Subject: Carlyle Greger, Carlyle Machine - To seek site plan approval for a new 10,950 sq. ft. building to manufacture prototypes in the medical industry located at 1671 East 145 South, consisting of approximately 1.00 acres. Application 25-023A

Planning Commission Staff Evaluation – Second Review

APPLICATION: 25-023A

STAFF COMMENTS – SECOND REVIEW

LANDSCAPE
PLAN

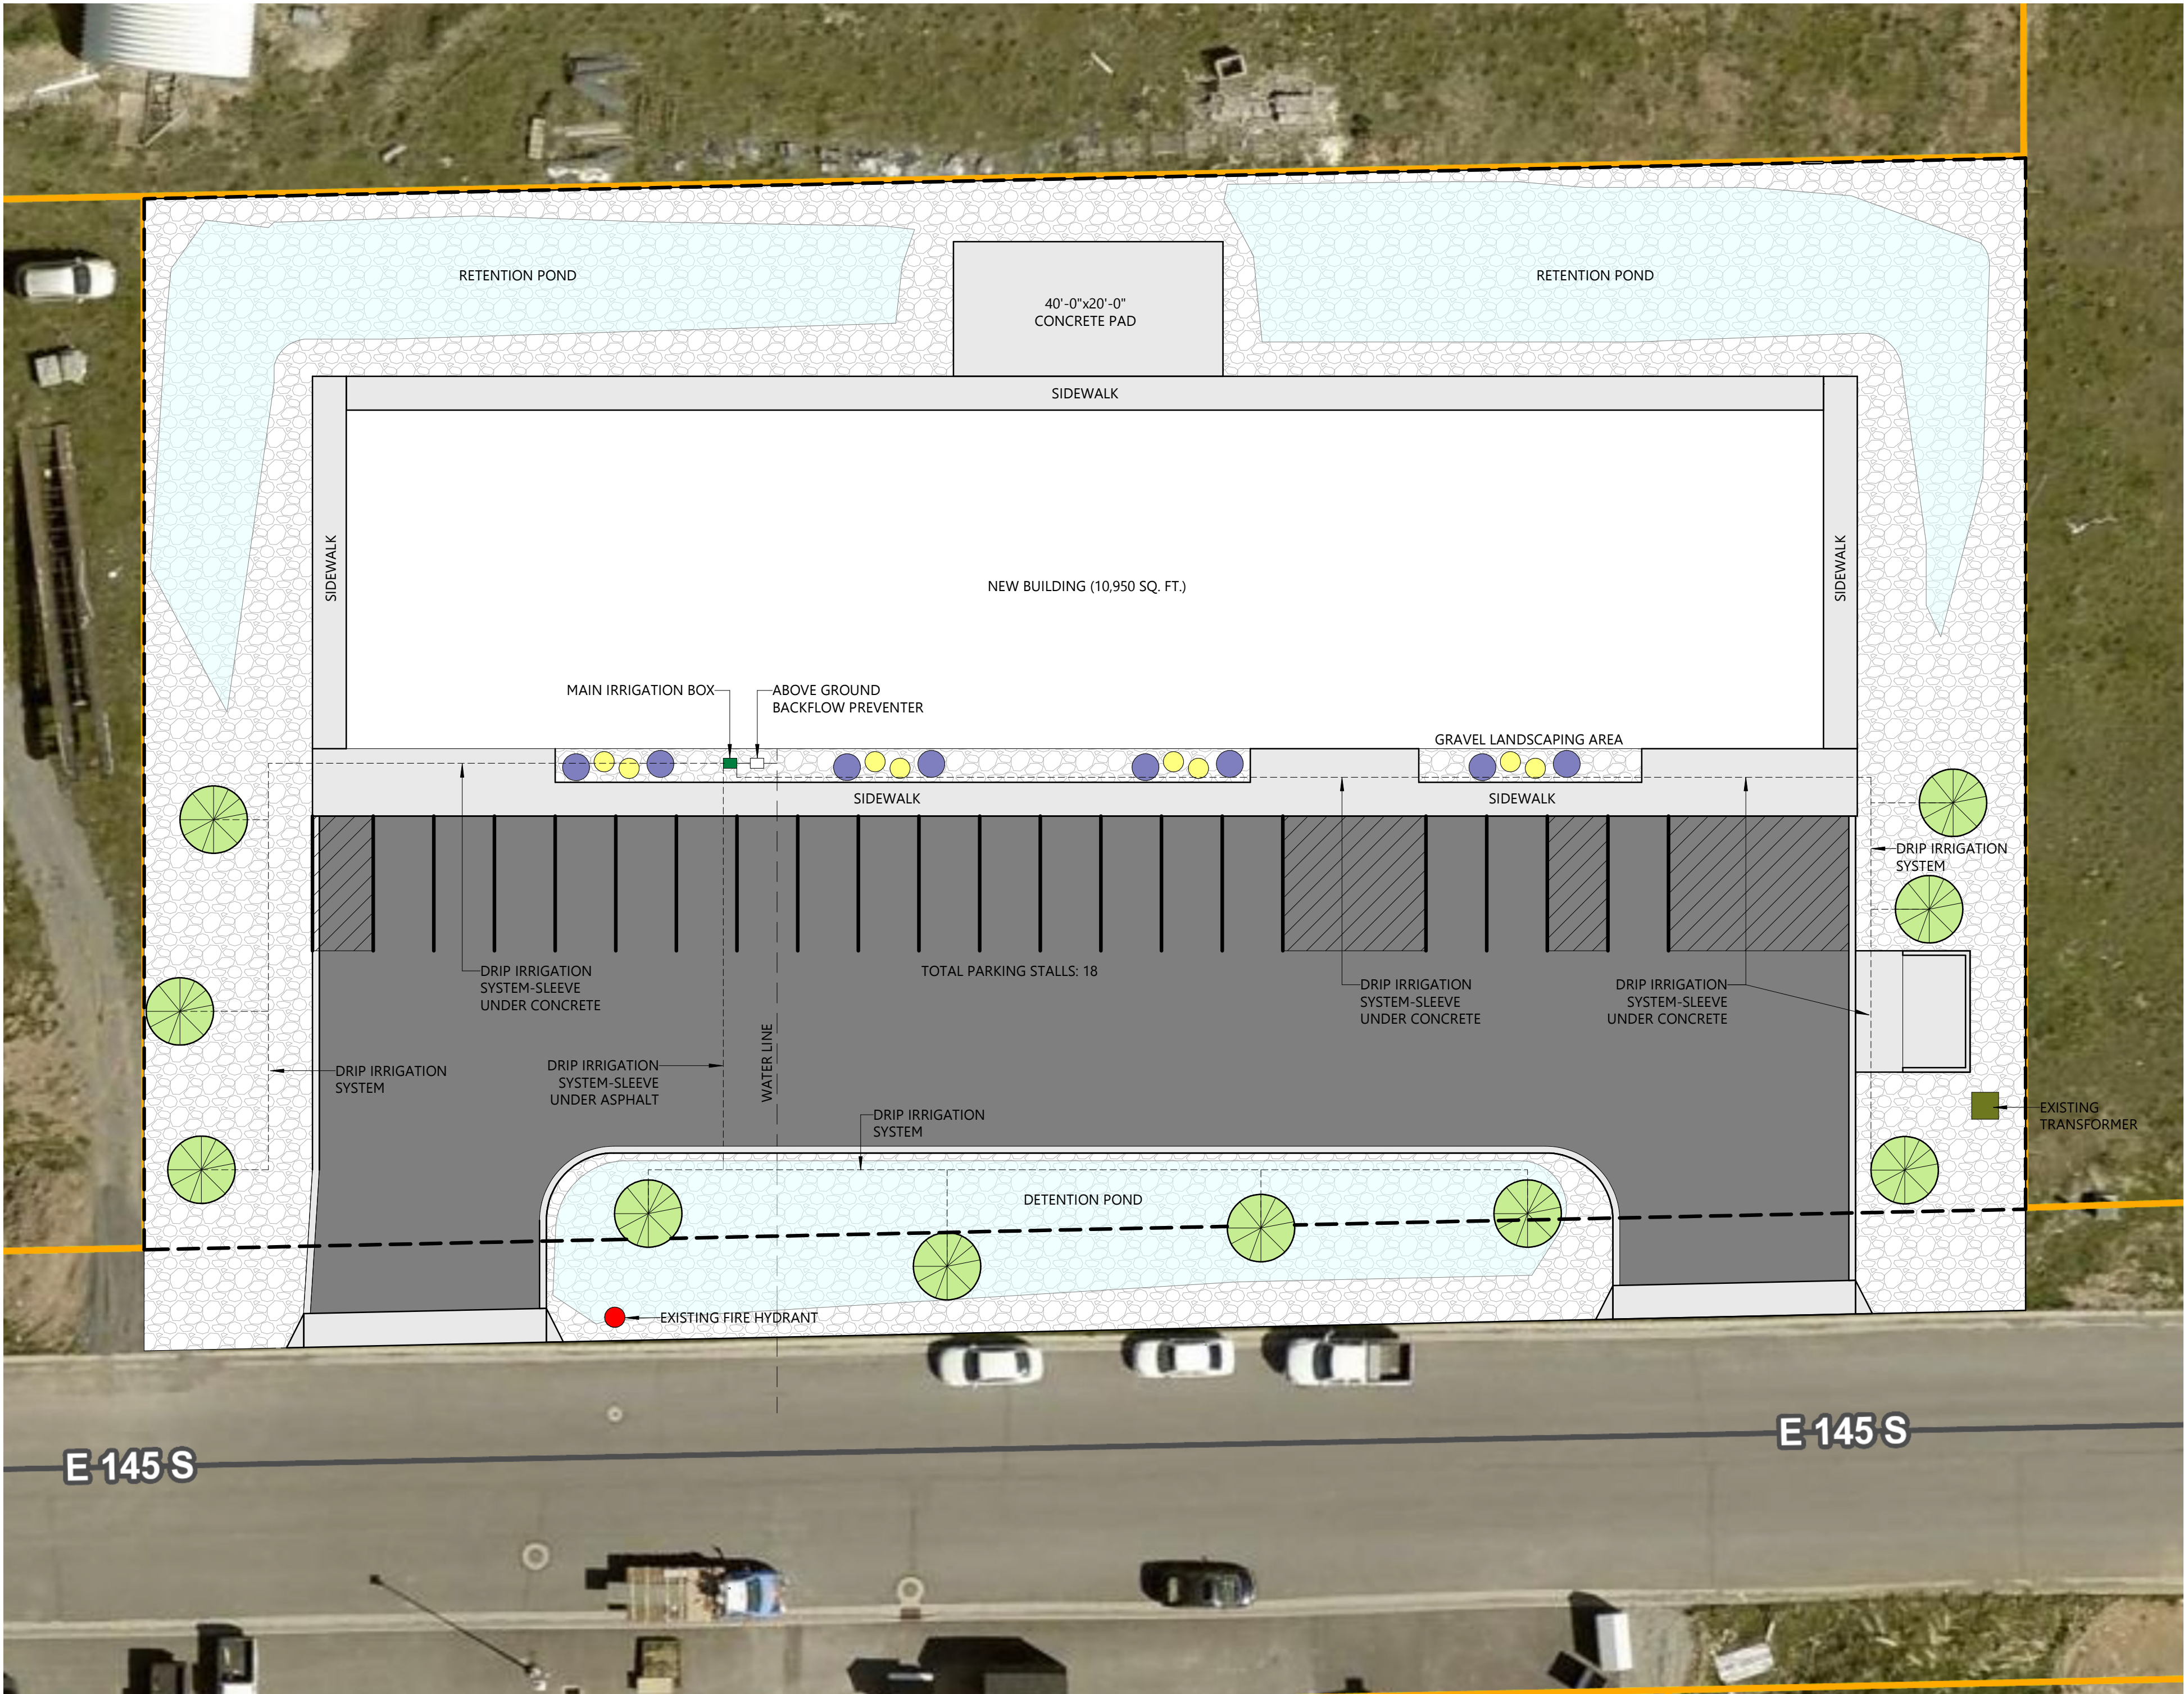
2. "Landscape Design By Others" is identified on Site & Utility Plan Sheet 1.1 but not provided for Site Plan Approval. Please submit the required landscape plan and appropriate maintenance plan for Site Plan Approval. See HCC 17.49.025. ?
